## SERVICE BULLETIN

**APPLICABILITY:** 2018-19MY WRX and WRX STI

**NUMBER:** 05-81-20

**SUBJECT:** Rear BILSTEIN® Shock Absorbers- Design Changes

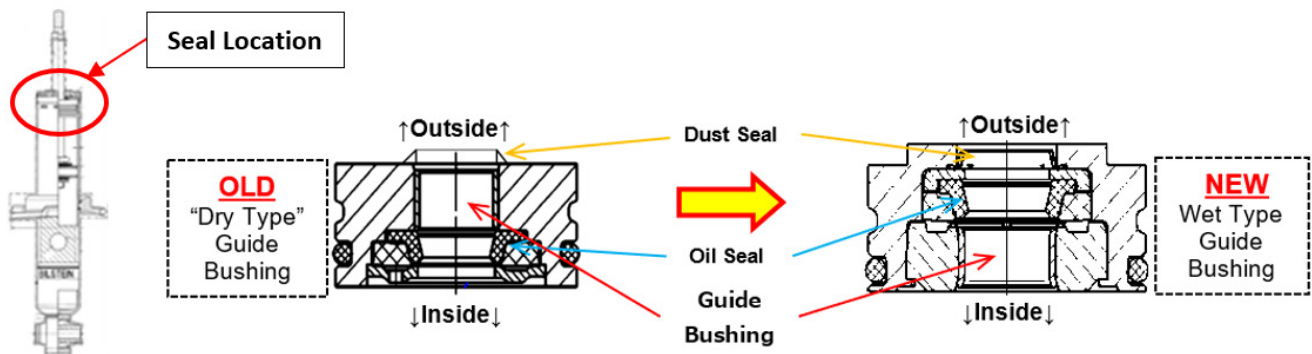
This bulletin announces design changes made to the BILSTEIN rear shock absorbers used on the models listed above. The changes listed below were made to enhance the durability of the seals and to prevent oil loss:

- guide bushing changed from a dry type to a wet type
- configuration of the guide bushing, oil seal and dust seal were changed.

The part number for the new SHOCK ABSORBER - REAR is **20365VA061**.
